Office Action Summary

10/786,294

GERAGHTY, WILLIAM F.

DETAILED ACTION

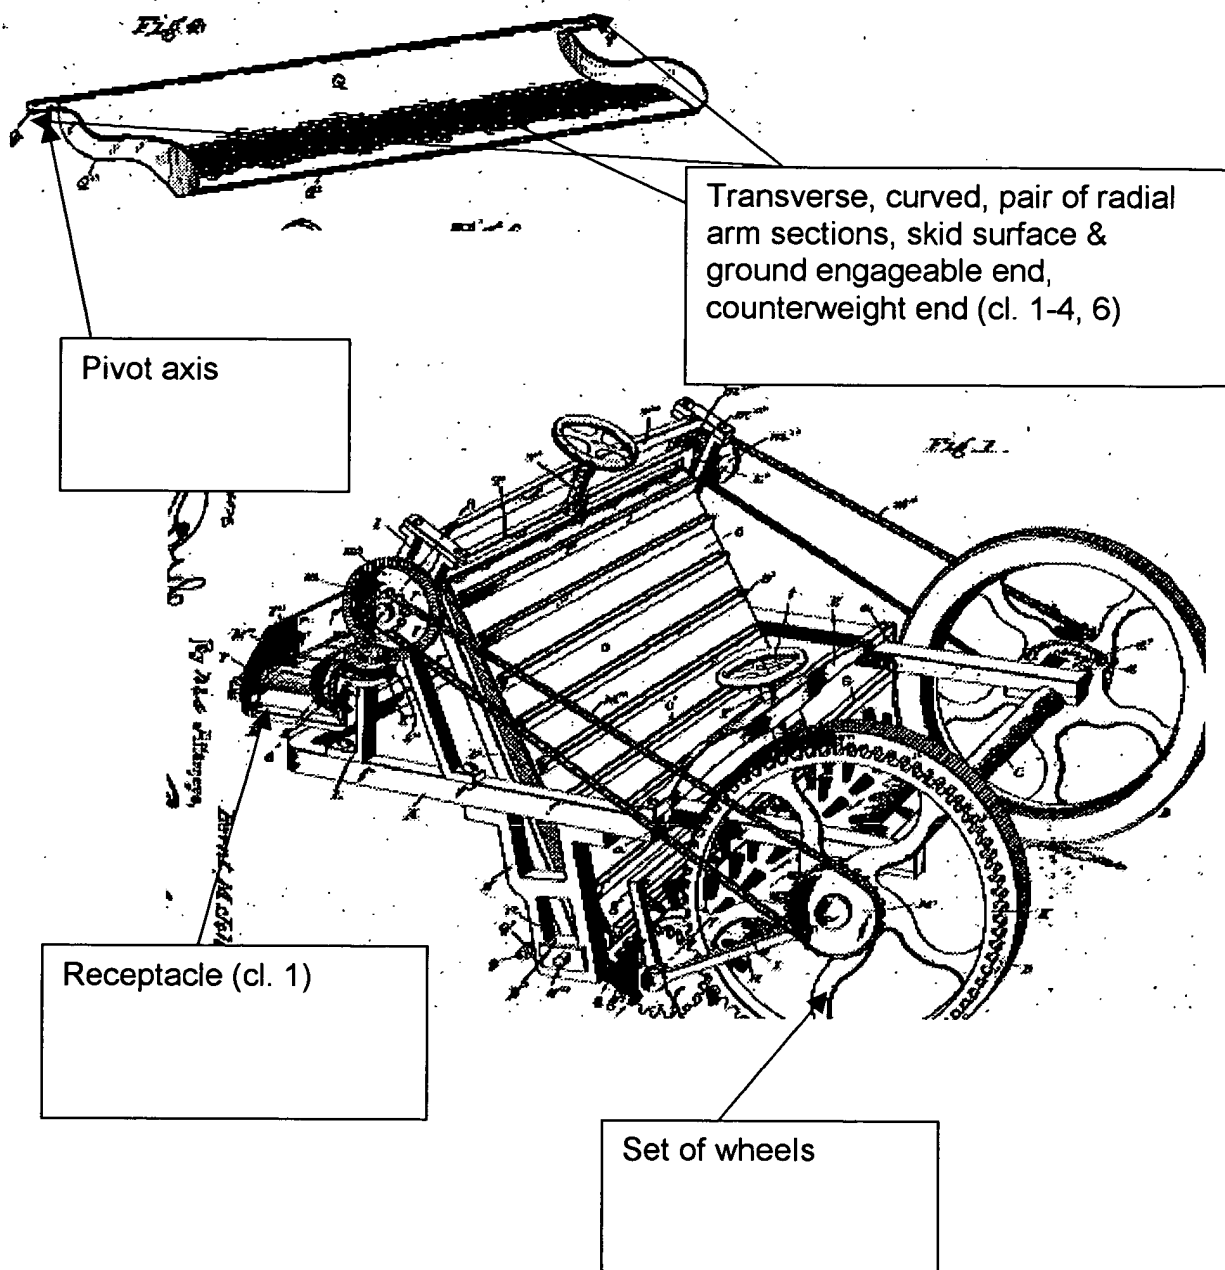
3. Claims 1-7 are rejected under 35 U.S.C. 102(b) as being anticipated by Johnson (501515).

Johnson discloses:

FIG. 6

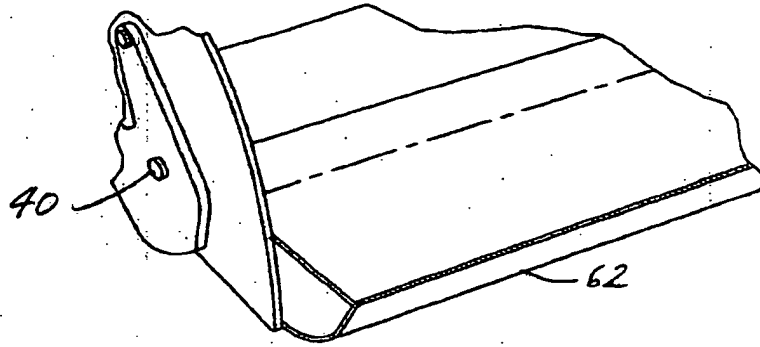
In re Applicant's argument, that (claim 6) the moldboard is not provided with "a ground engageable end and a counter weight end," the examiner would point fig 6, showing a ground engageable end at ref Q' and a counter weight Q".
